From: Nielsen, Janice L CIV NAVFAC MidLant  
Sent: Monday, October 06, 2008 9:55 AM  
To: Capito, Bonnie P CIV NAVFAC Lant  
Subject: MCAS Cherry Point Proposed Plan OU2 well replacement

From: Erica DeLattre [mailto:erica@rhea.us]  
Sent: Tuesday, September 30, 2008 3:02 PM  
To: Gena Townsend; George Lane  
Cc: Nielsen, Janice L CIV NAVFAC MidLant  
Subject: OU2 well replacement

FIGURE 1  
MONITORING WELL DETAIL  
OU2 WELL REPLACEMENT

**Figure 4**  
**Sampling Locations**  
**Long-Term Monitoring, OU2**  
**MCAS Cherry Point, North Carolina**

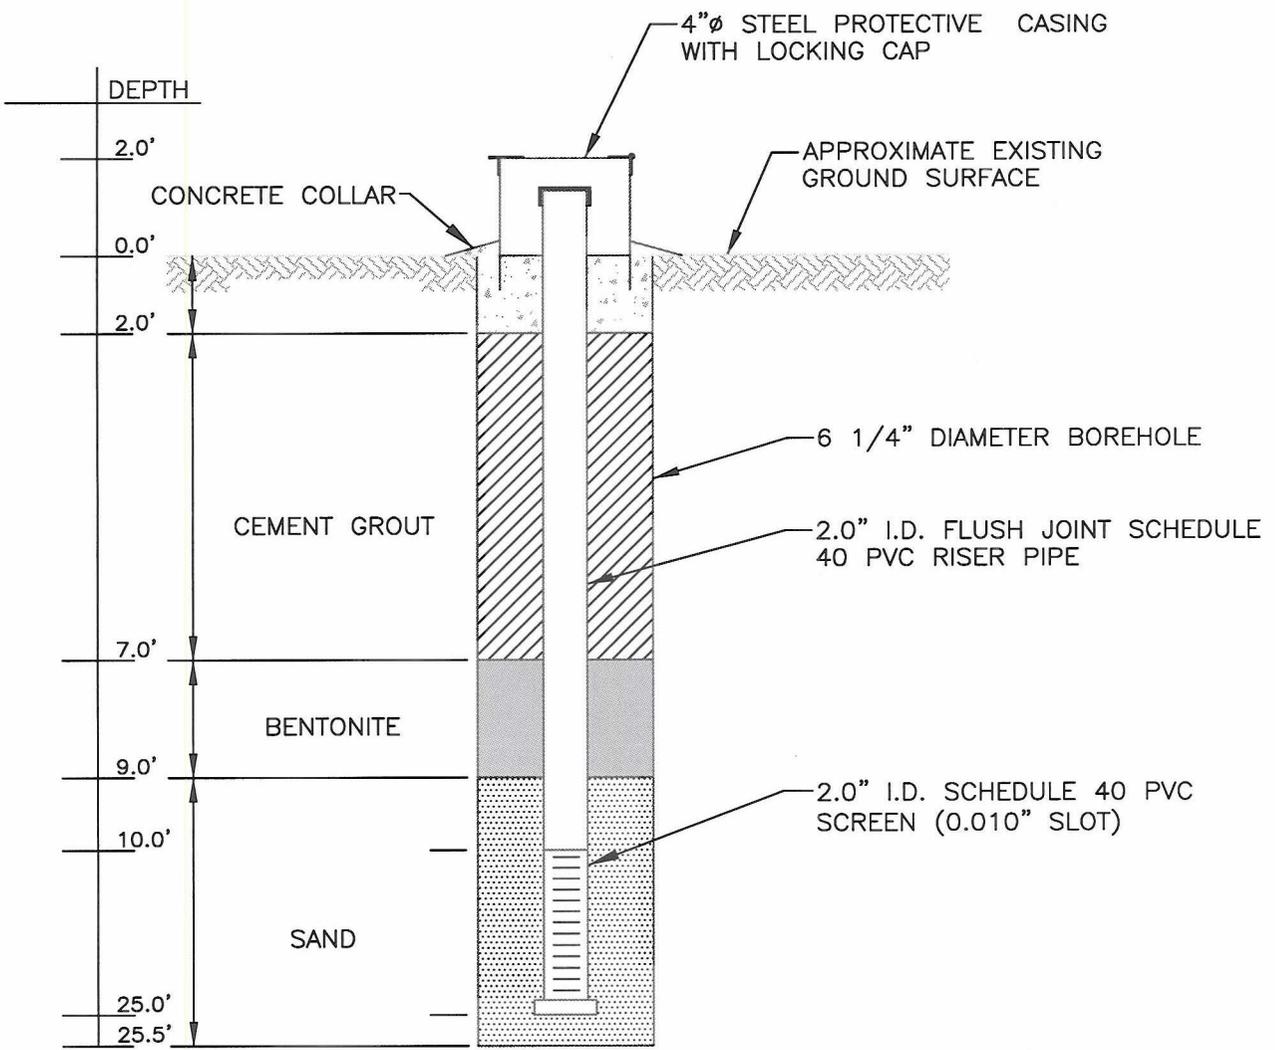
As I presented to the Partnering Team on May 8, 2008, the team agreed that we should replace OU2 wells 10EGW-03 and 10EGW-05. Both of these wells are 20 feet deep. The screened interval of 10EGW-03 is 15 to 20 feet. The screened interval for 10EGW-05 is unknown. The surficial aquifer "EGW" wells typically have a screened interval of 15 to 20 feet. The surficial aquifer of the "GW" wells typically have a screened interval of 10 to 25 feet and obviously they are 25 feet deep.

Due to the fact that on several occasions, the water level is above the screened interval on 10EGW-03, I propose that the new wells that replace these wells be 25 feet deep with a screened interval of 10 to 25 feet. I have also attached a site plan with well locations and a schematic of the wells installation details. Please review this and let me know if it is acceptable.

I agree with George

Hi Team,  
I see no problem with this proposal. It is approved.
